ADDENDUM NO. 2

PROJECT NO. DGS C-0946-0012 PHASE 006

PROJECT TITLE - PA State Museum & PHMC Tower - Infrastructure Upgrades and Renovations

Design Resources Group Architects AIA
270 Davidson Ave, Suite 303
Somerset, NJ, 08873

DRAWING SET IS INTENDED FOR COLOR PRINTING

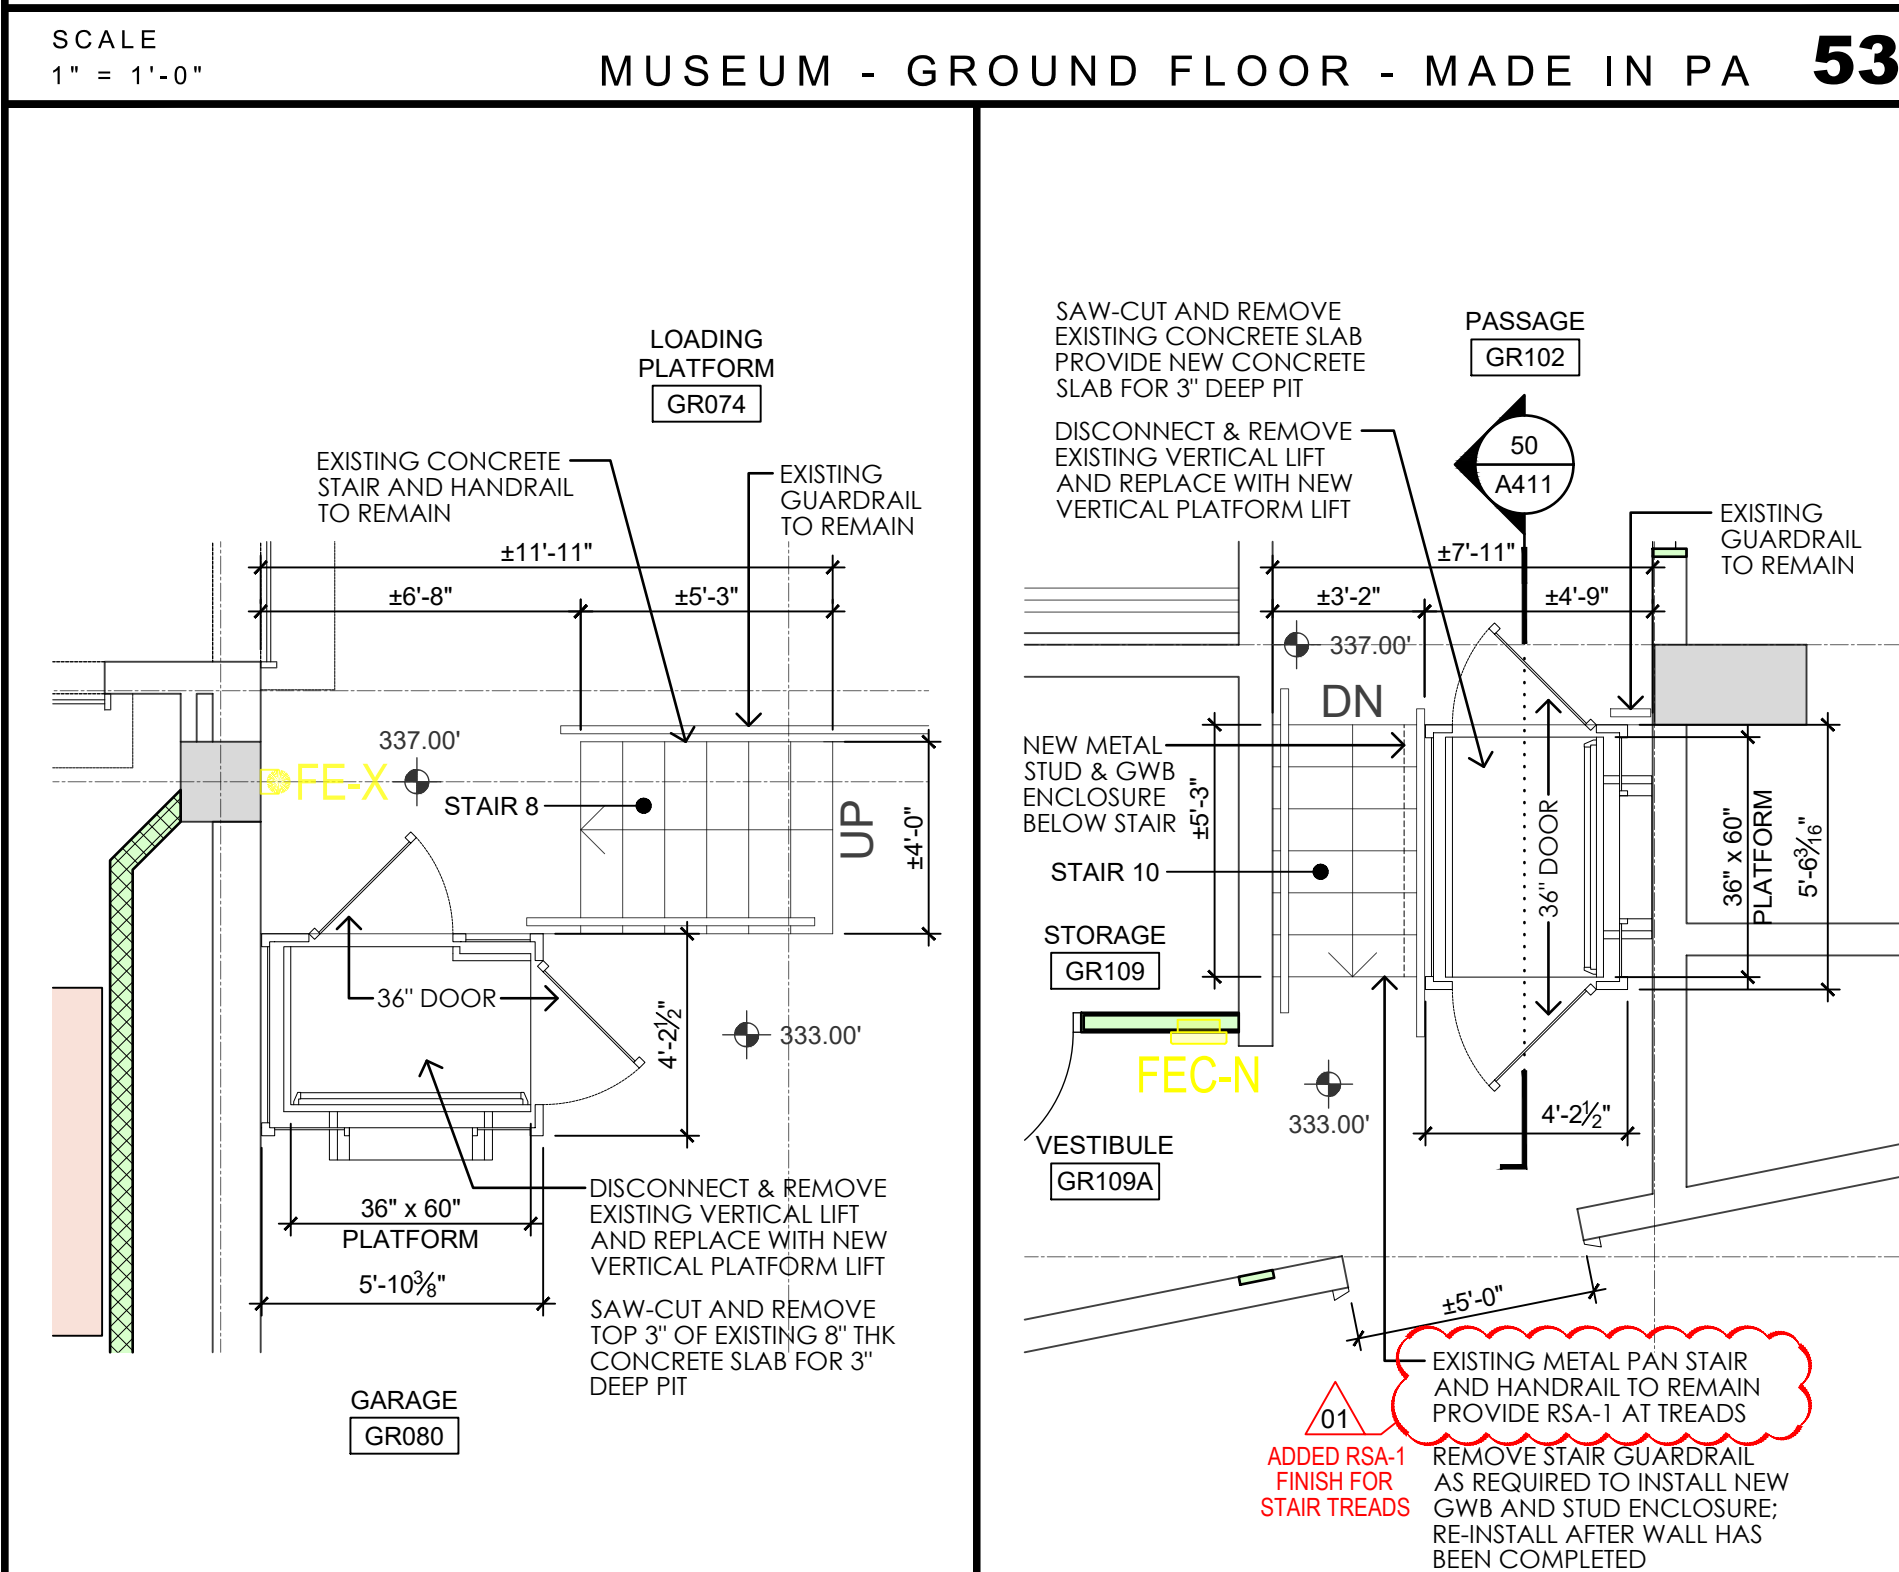
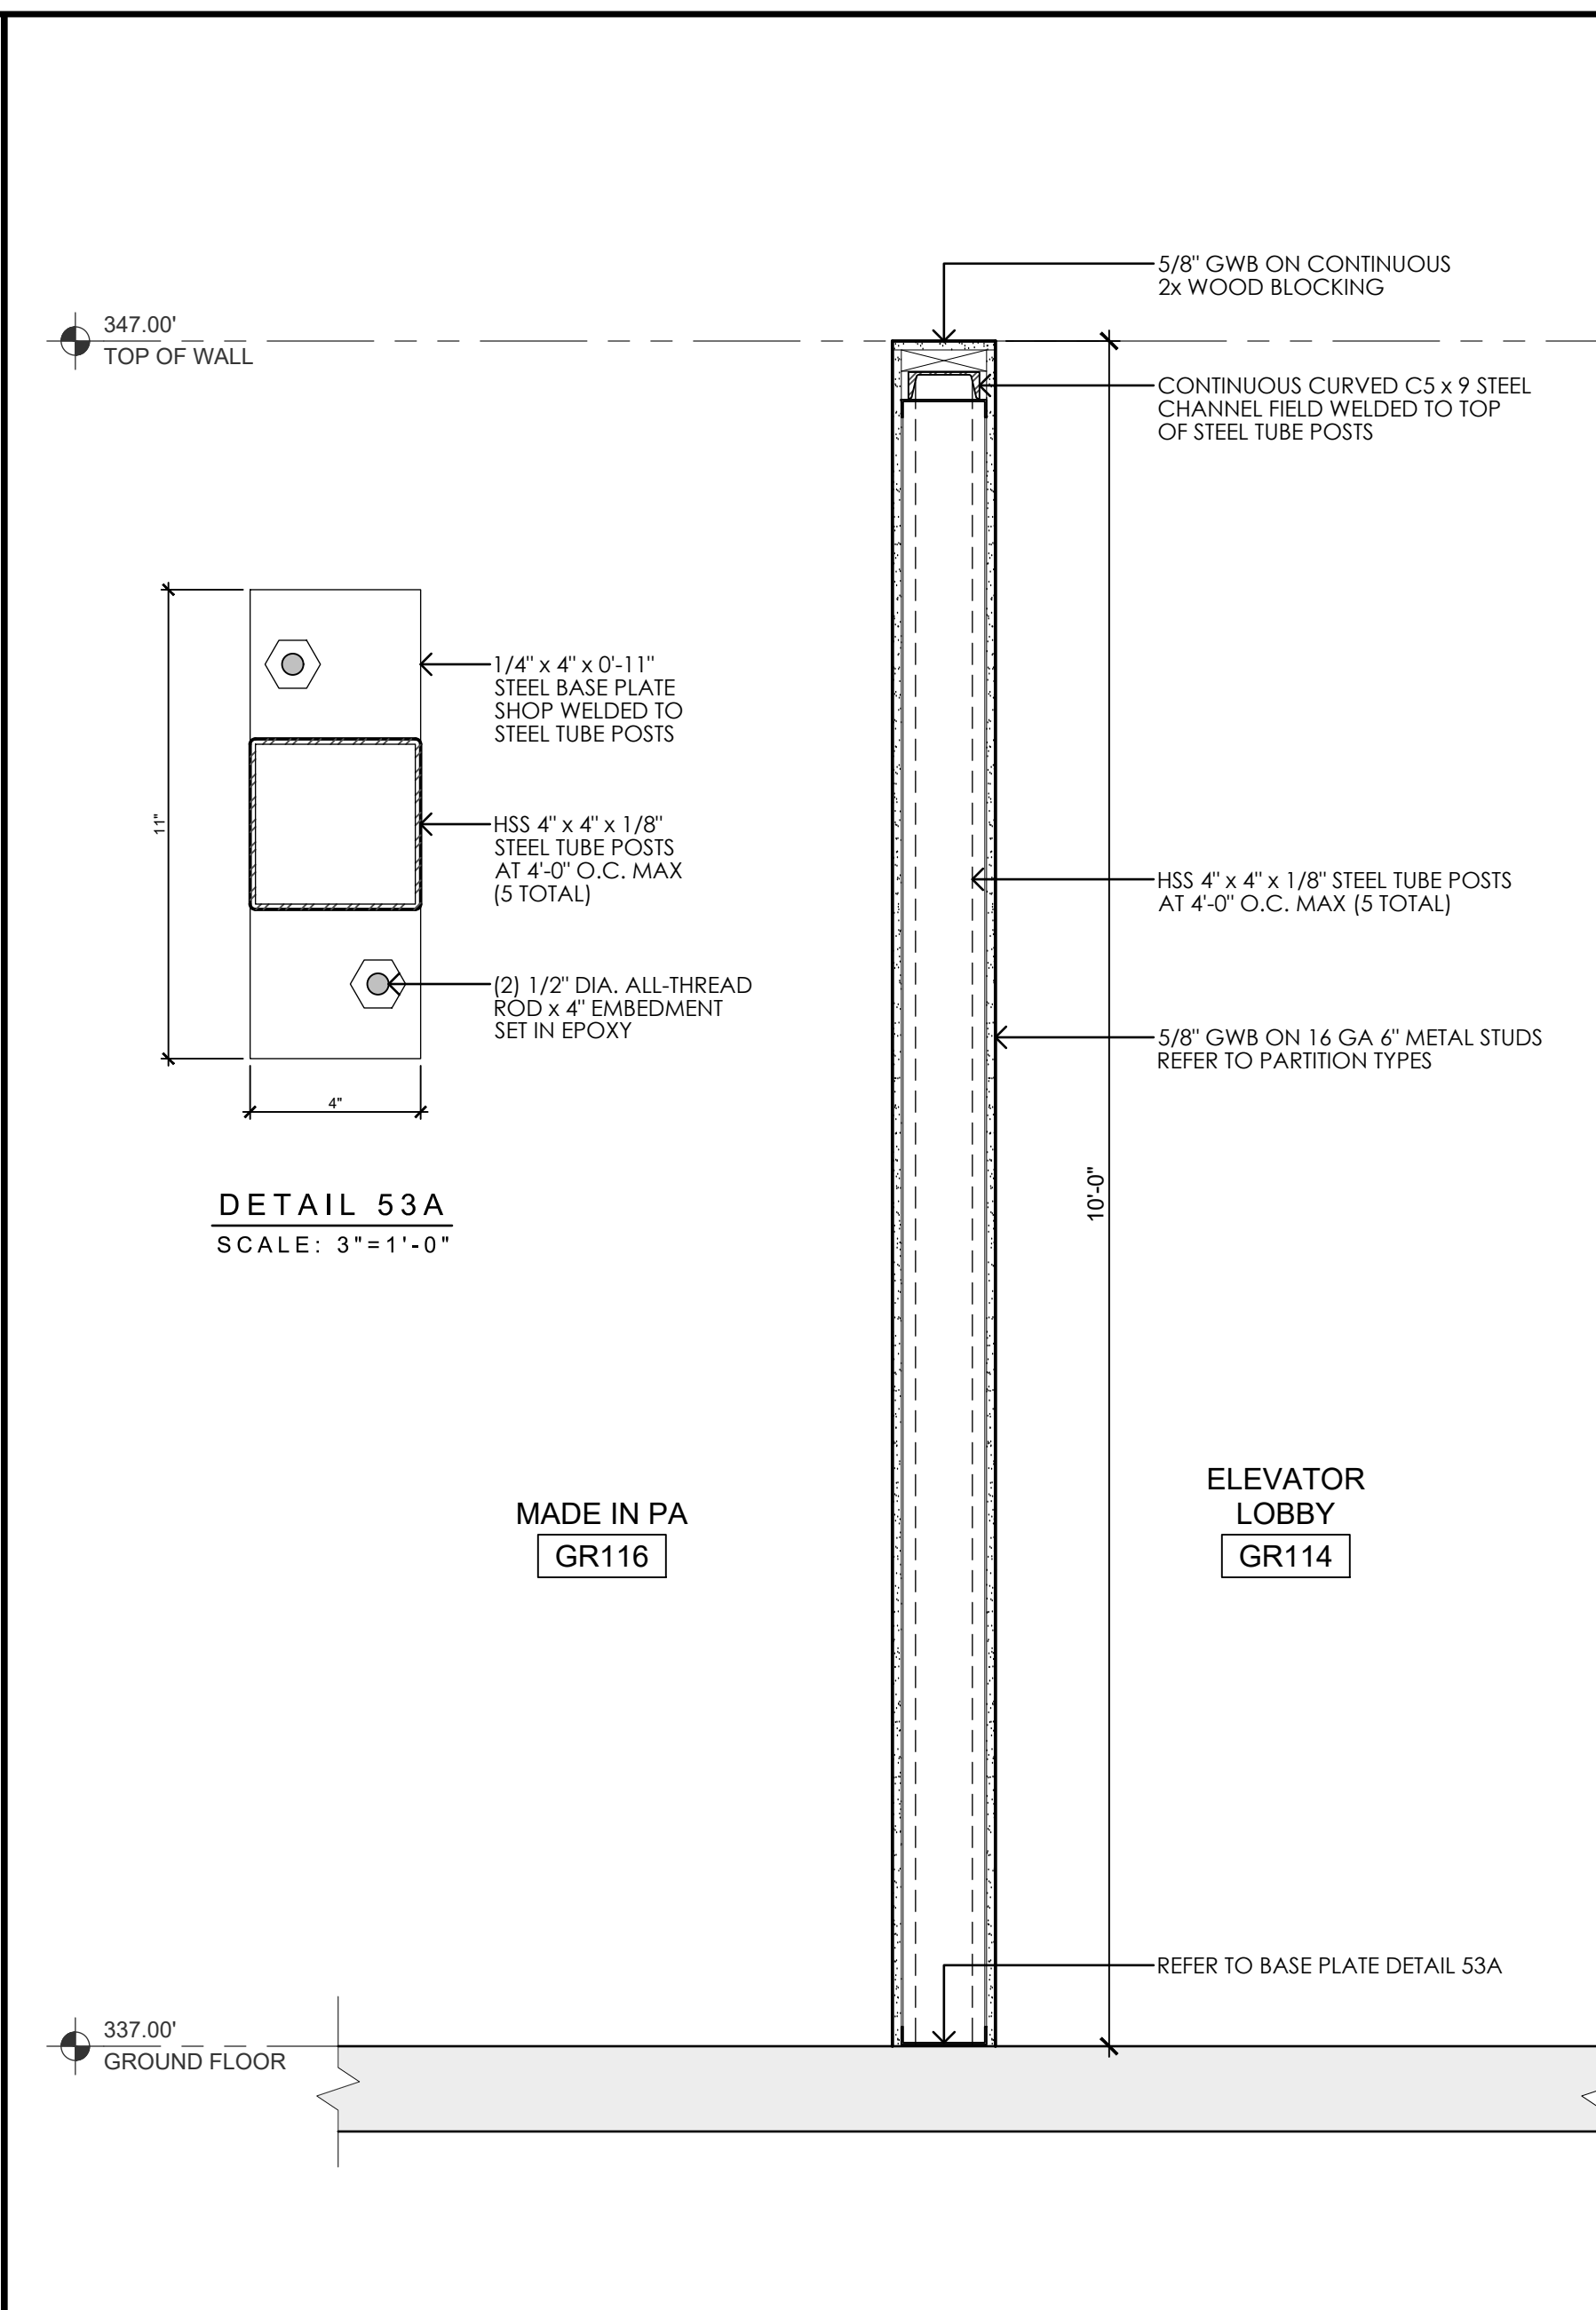
Item 26 - Drawing A410 - At Detail 47, corrected detail reference to 29/A424.
